Report No. 10CFR21-0069
April 25, 1994

10CFR21 REPORTING OF DEFECTS
AND NON-COMPLIANCE

COMPONENT: Voltage Relay - EMD 8412411, 8282624, 8365716
Westinghouse Type SV

SYSTEM: EMD Type 999 and MP-45 Diesel Generators

MP-45

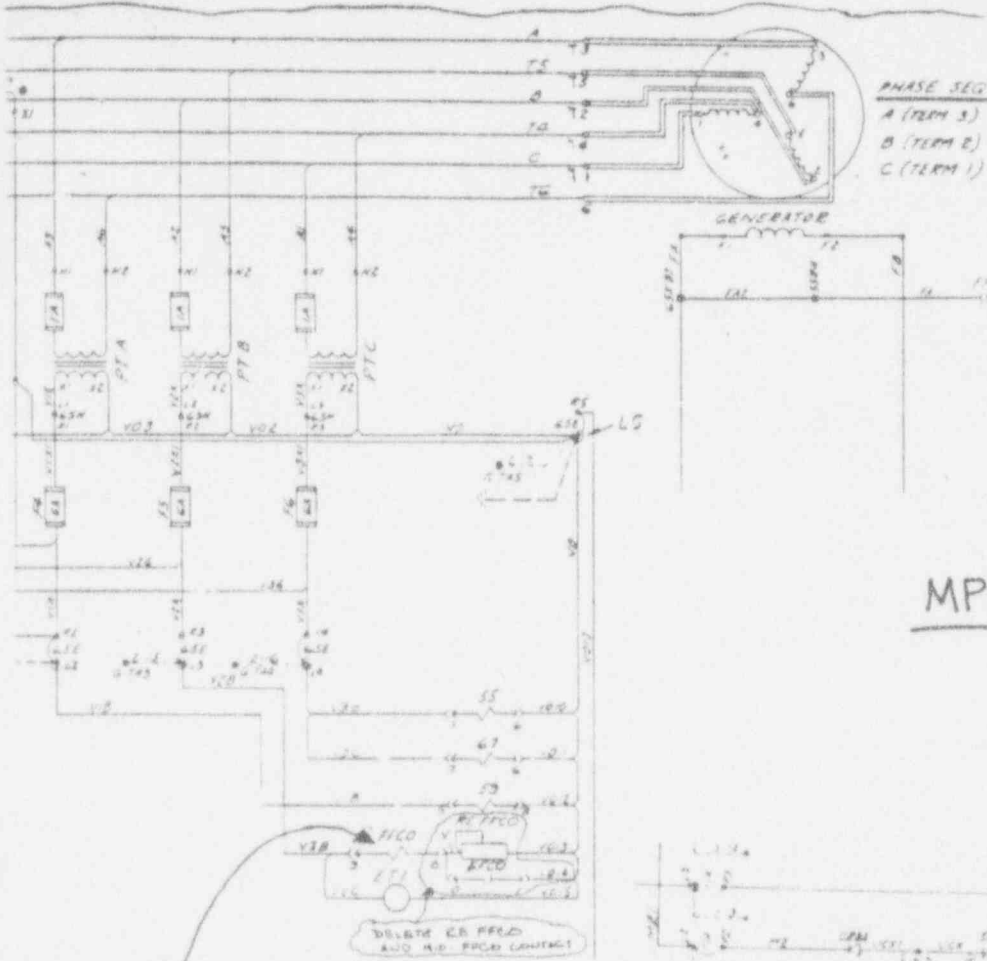
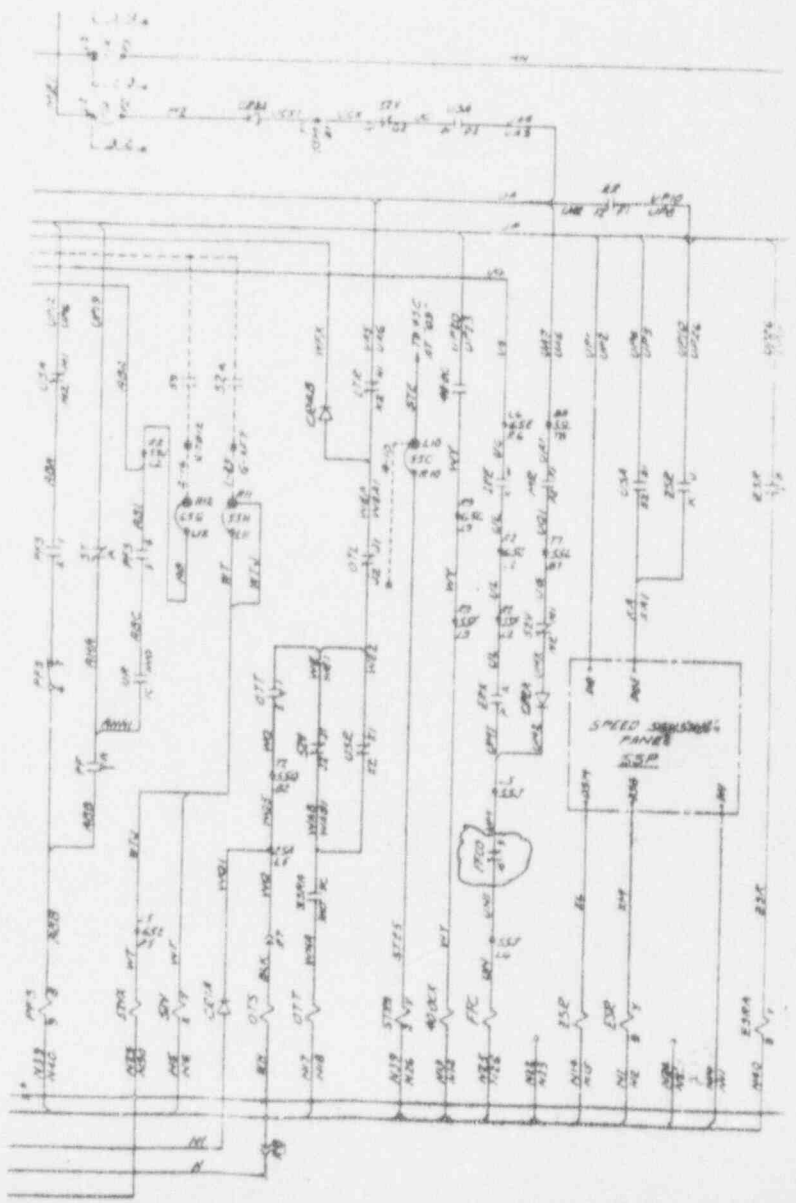
Wiring of the replacement relays will remain the same as shown on the unit's wiring schematics, except for MP-45 machines. See Exhibit 1, MP-45 circuitry, for deletion of RE-FFCO and parallel N.O. contact.

NEW FFCO COILS
 WIRE DIRECTLY ACROSS
 120 VAC POTENTIAL.
